802.16e™

# Part 16: Air Interface for Fixed and Mobile Broadband Wireless Access Systems

## Amendment 2: Physical and Medium Access Control Layers for Combined Fixed and Mobile Operation in Licensed Bands

**IEEE Std 802.16e™-2005** *and*
**IEEE Std 802.16™-2004/Cor1-2005**
(Amendment and Corrigendum to
IEEE Std 802.16-2004)

**Figure 11—PHS signaling example**

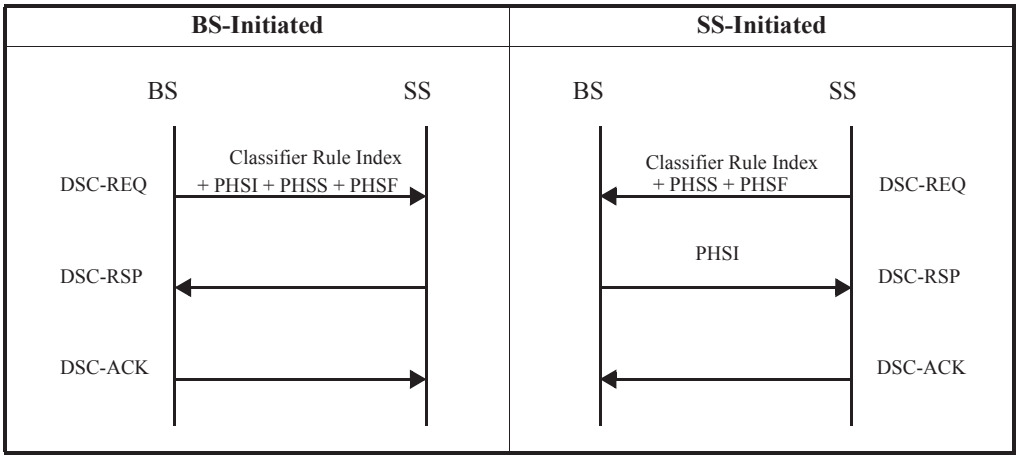
***Replace Figure 11 with the following figure:***

**Figure 34—ARQ Reset message dialog—transmitter initiated**

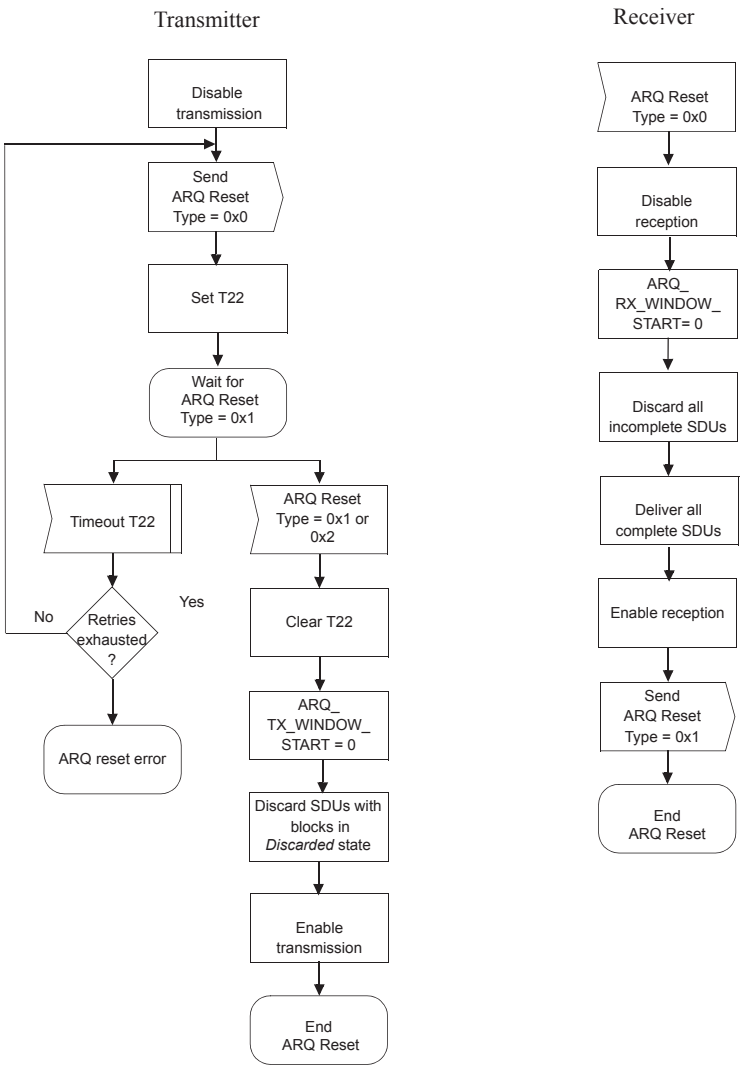
***Replace Figure 34 with the following figure:***

When in ARQ reset error state in Figure 34 and Figure 35, the SS shall re-initialize its MAC, the behaviour for BS is implementation dependant.

**Figure 35—ARQ Reset message dialog—receiver initiated**

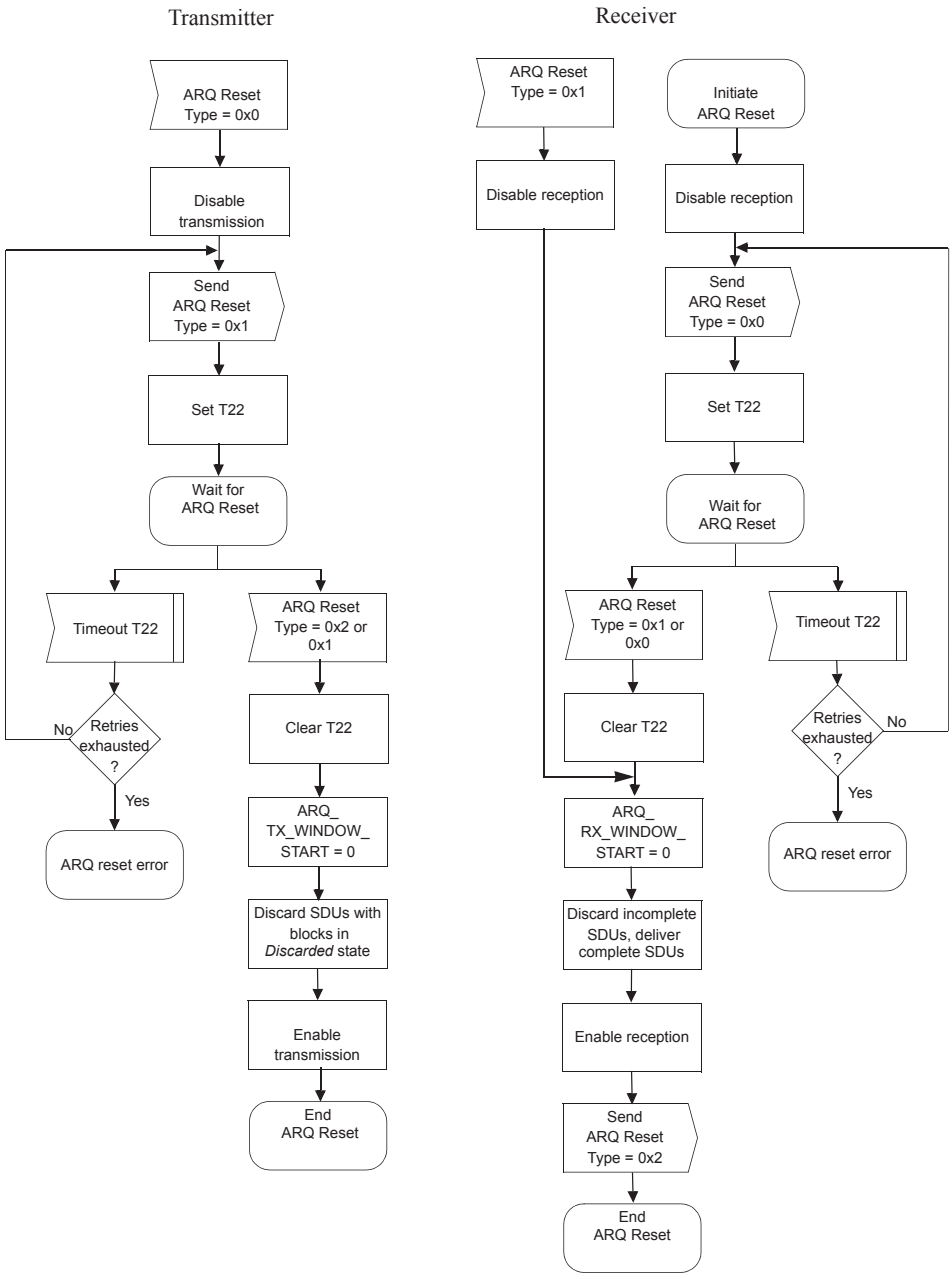
***Replace Figure 35 with the following figure:***

**Figure 36—ARQ block reception**

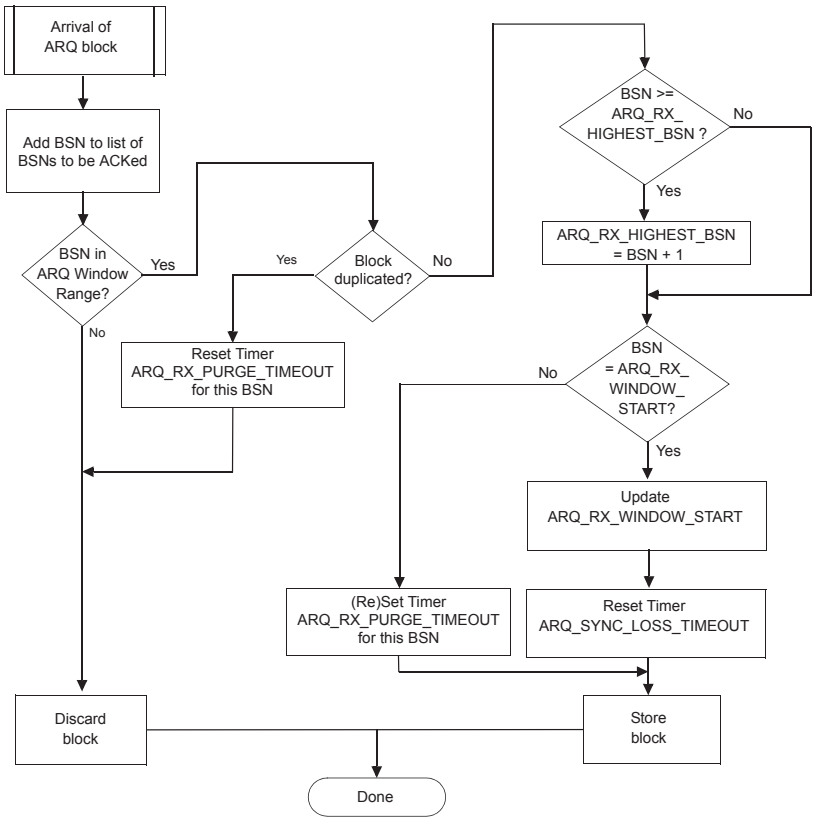
***Replace Figure 36 with the following figure:***

Figure 61 – Initial Ranging – SS (part 2)

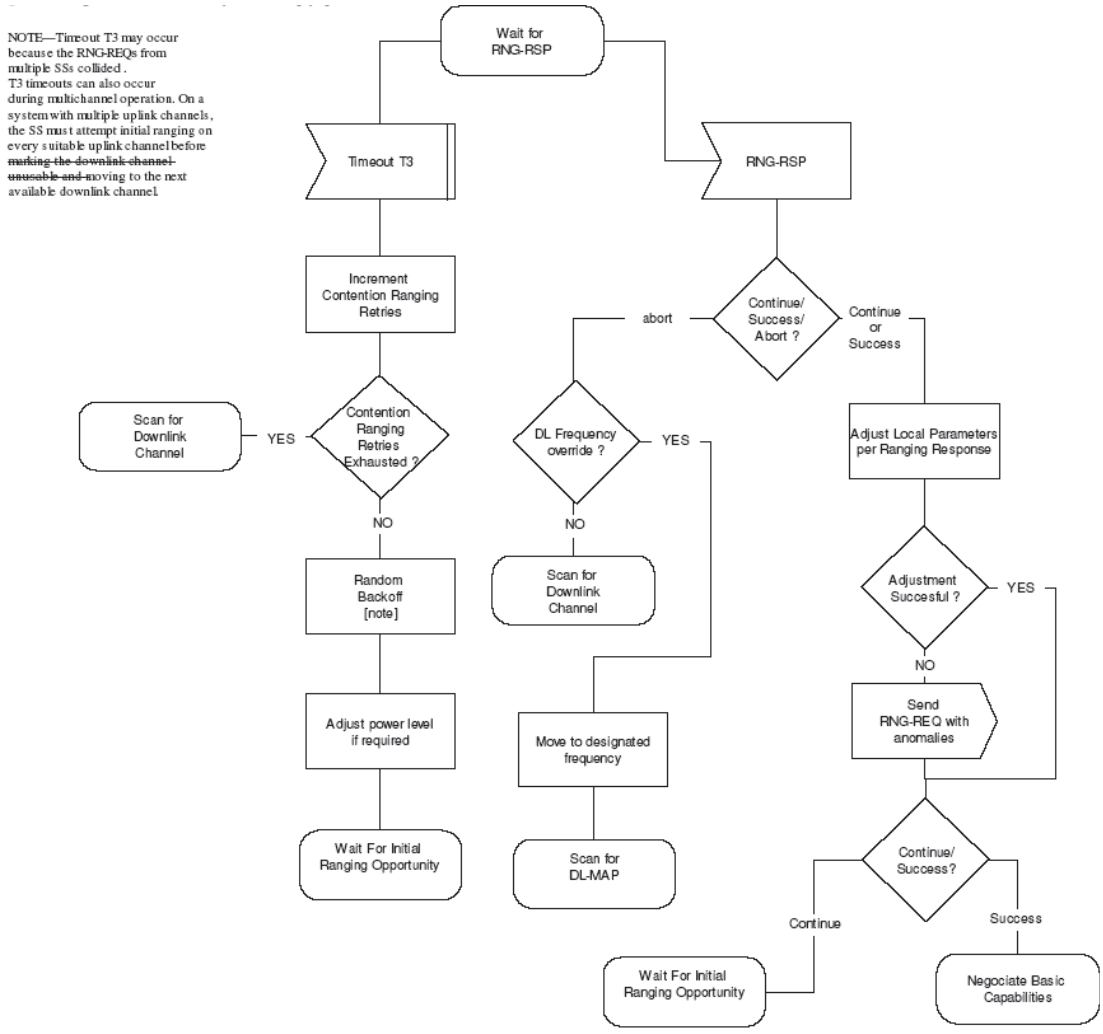
***Replace Figure 61 with the following figure:***

**Figure 70—Registration—BS**

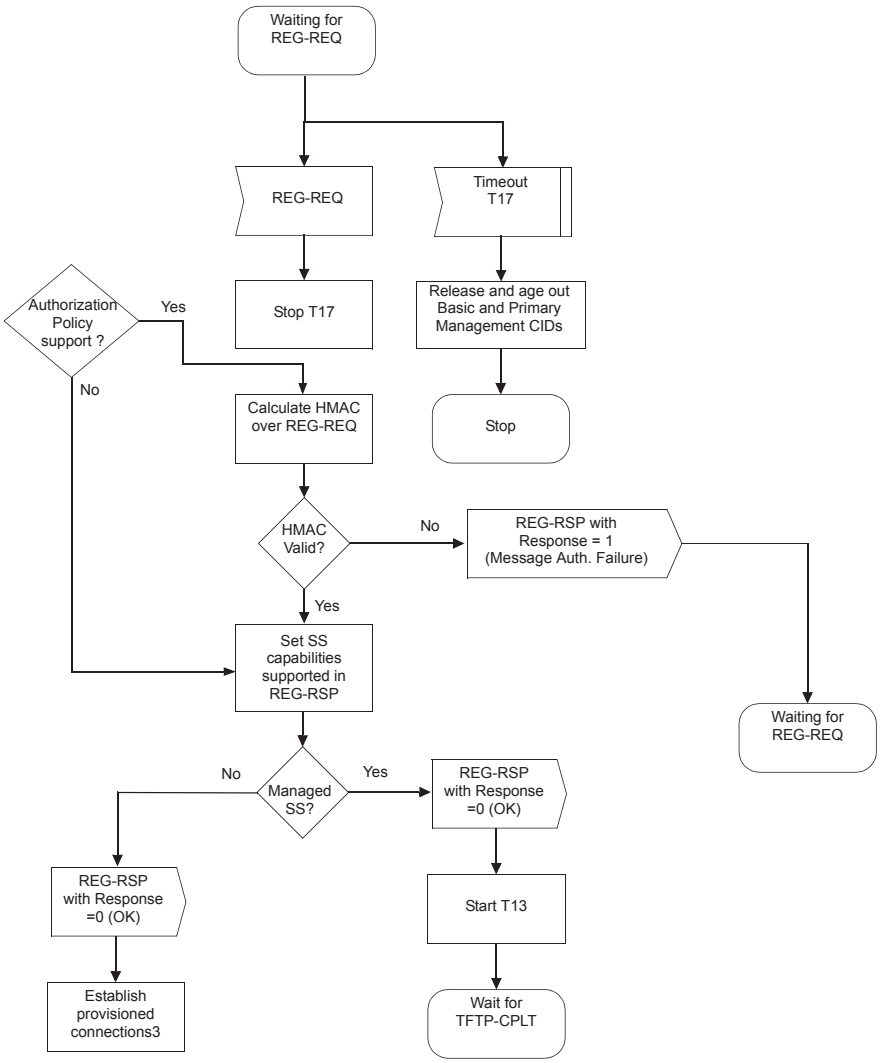
***Replace Figure 70 with the following figure:***

**Figure 80a—State transition diagram for downlink burst profile management—SS**

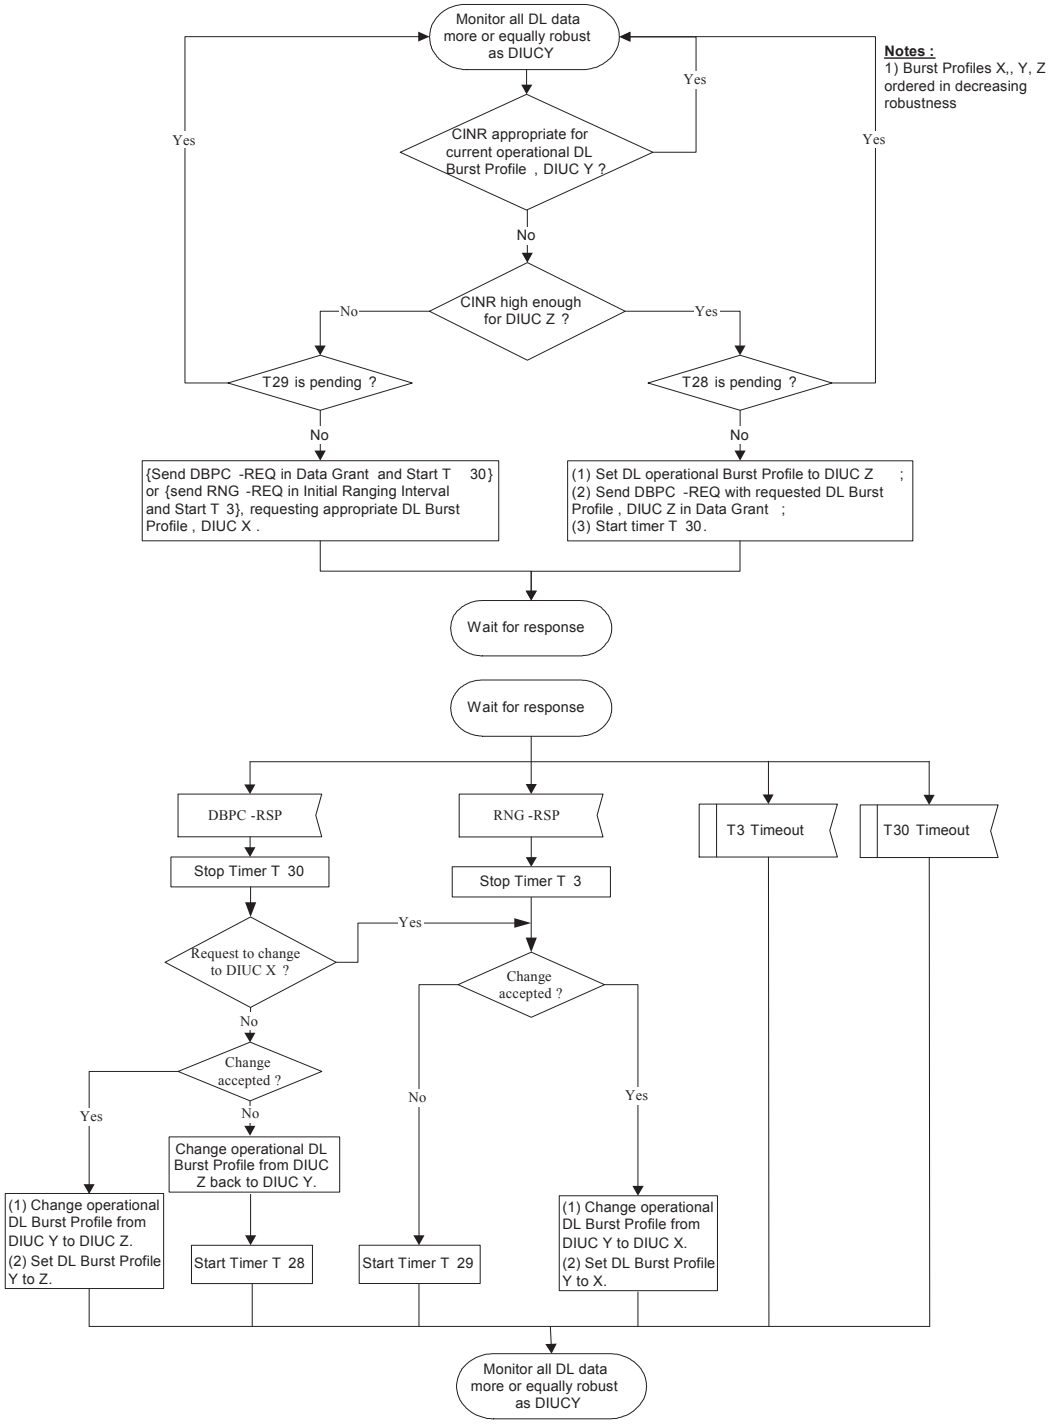
***Insert new Figure 80a:***

**Figure 82—Periodic Ranging receiver processing—BS**

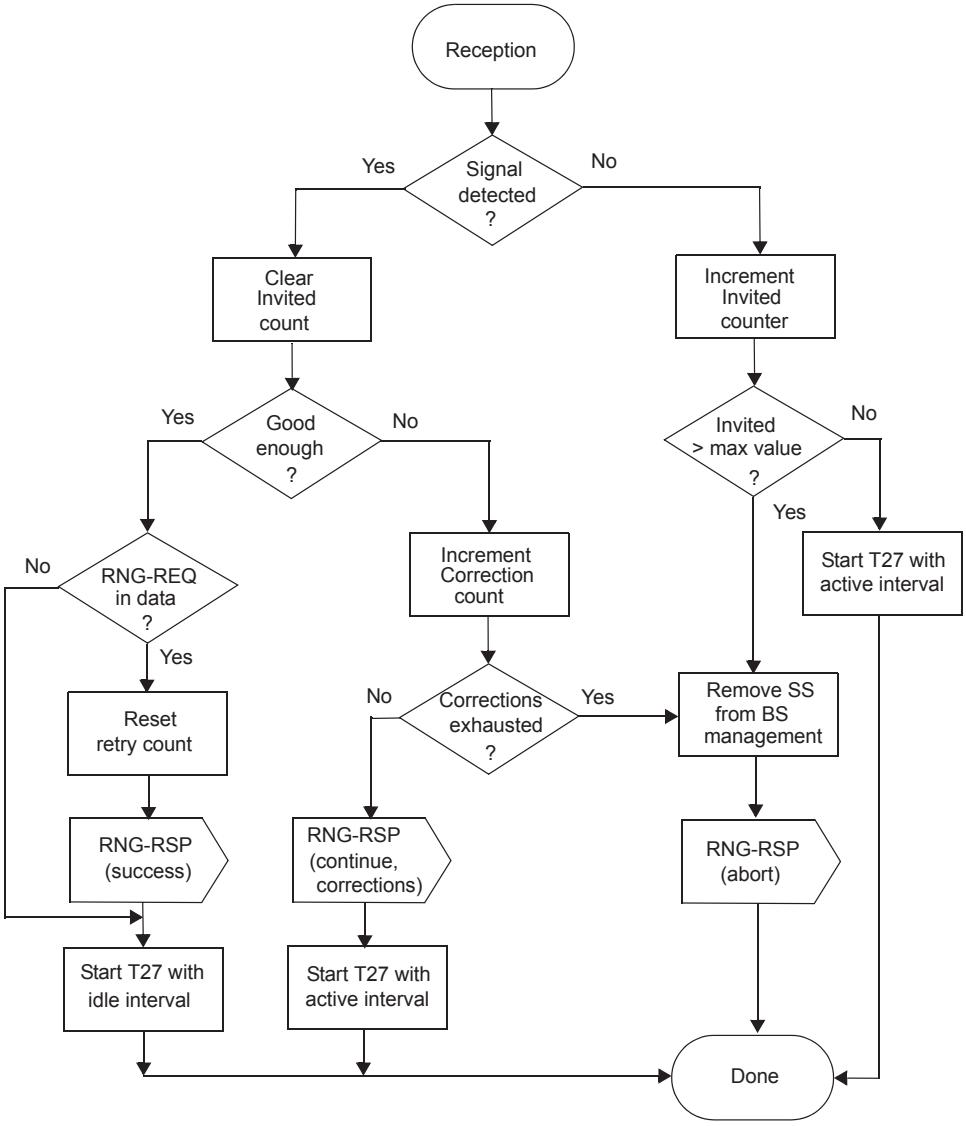
***Replace Figure 82 with the following figure:***

**Figure 84—Periodic Ranging—SS**

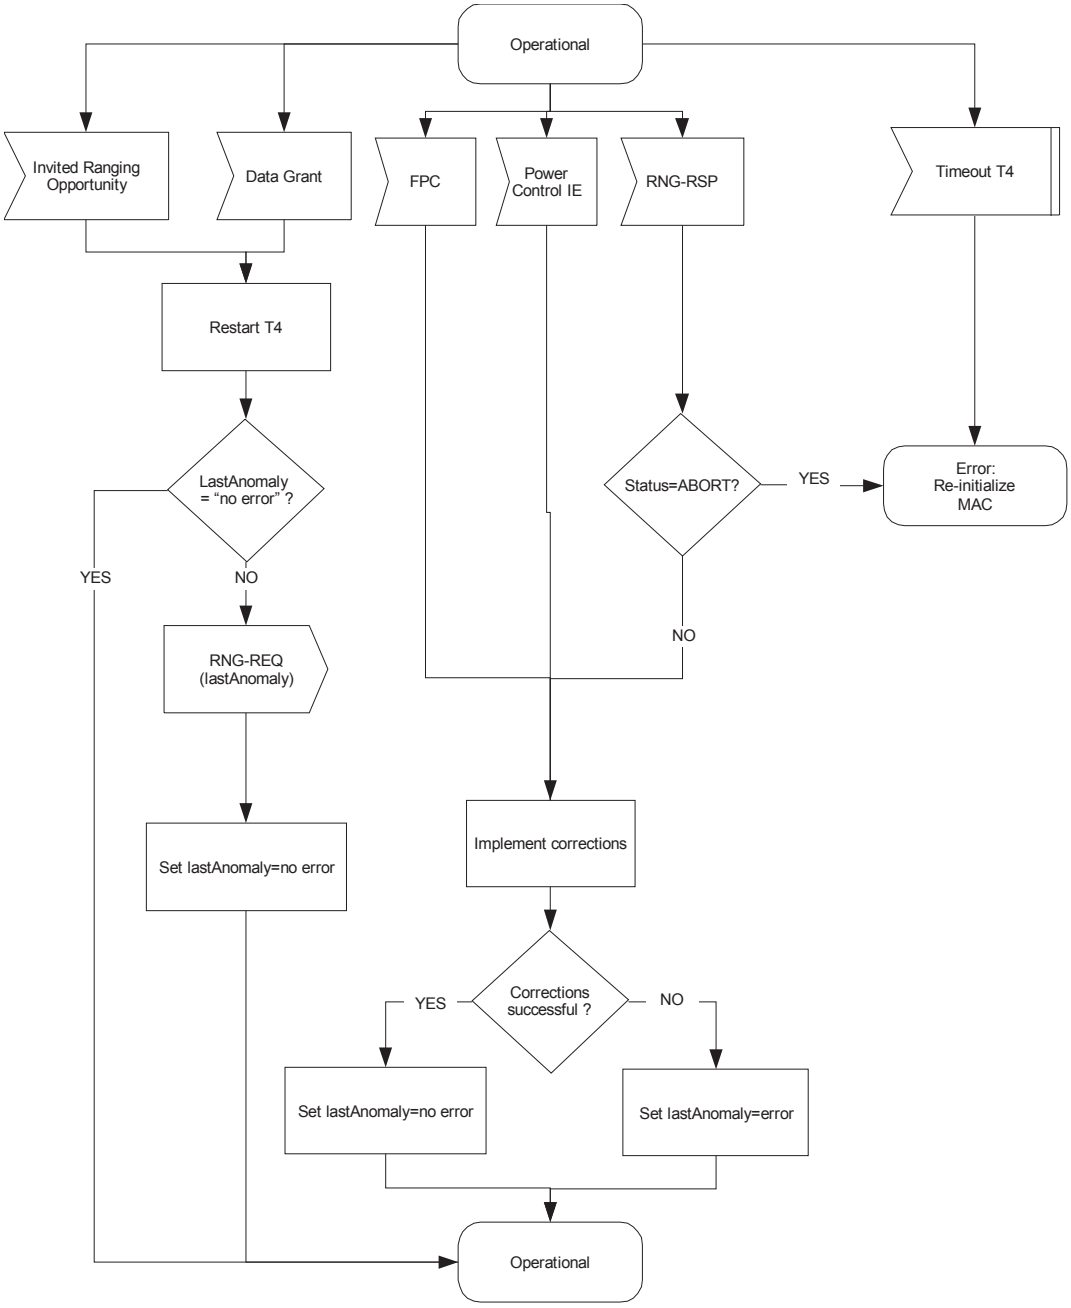
***Replace Figure 84 with the following figure:***

**Figure 86—CDMA Initial Ranging—SS (part 2)**

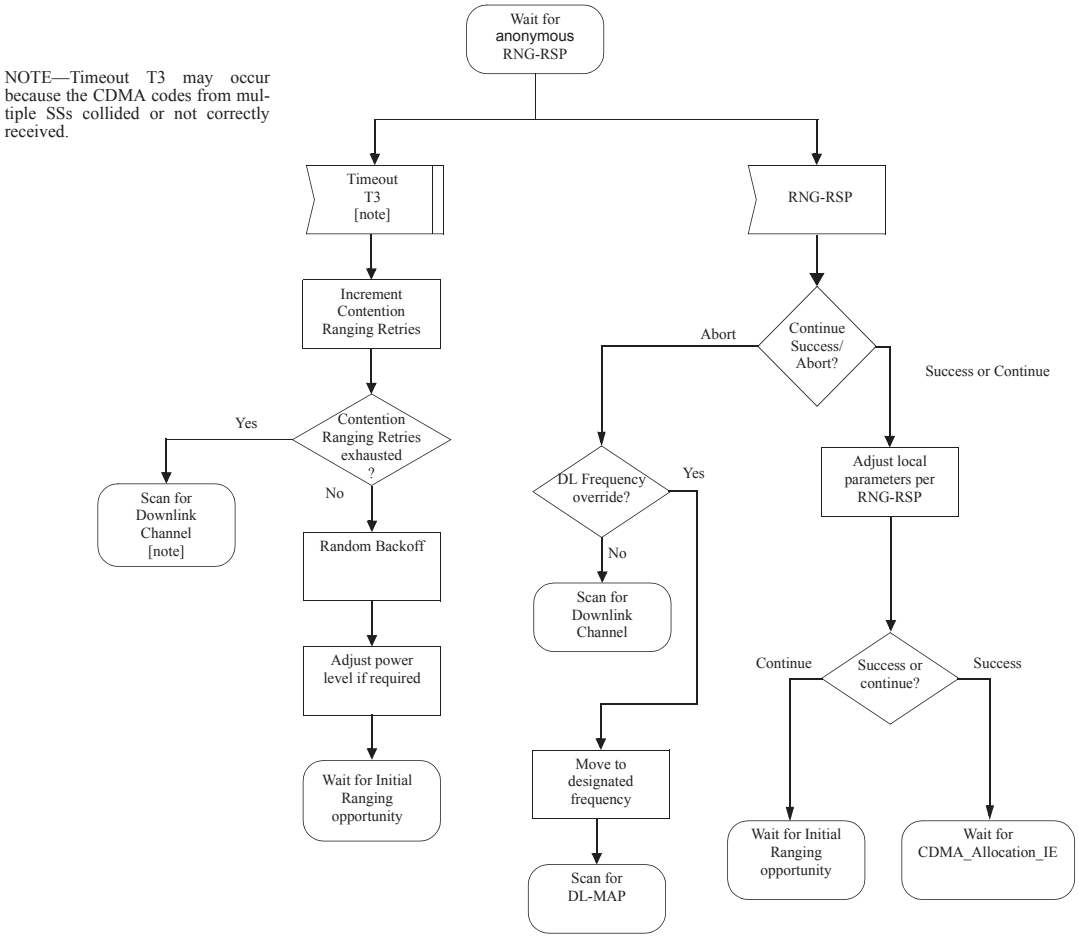
***Replace Figure 86 with the following figure:***

**Figure 90—Periodic CDMA ranging—SS**

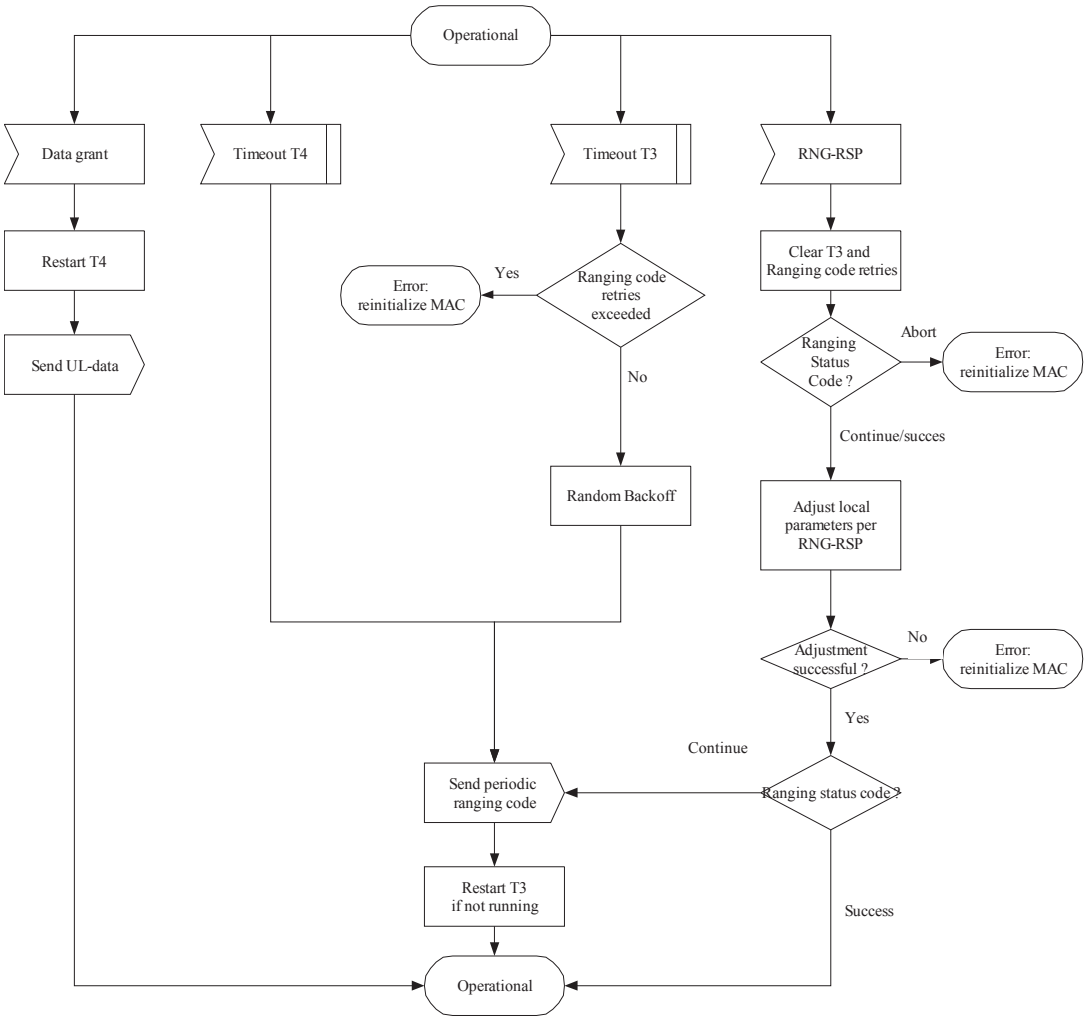
***Replace Figure 90 with the following figure:***
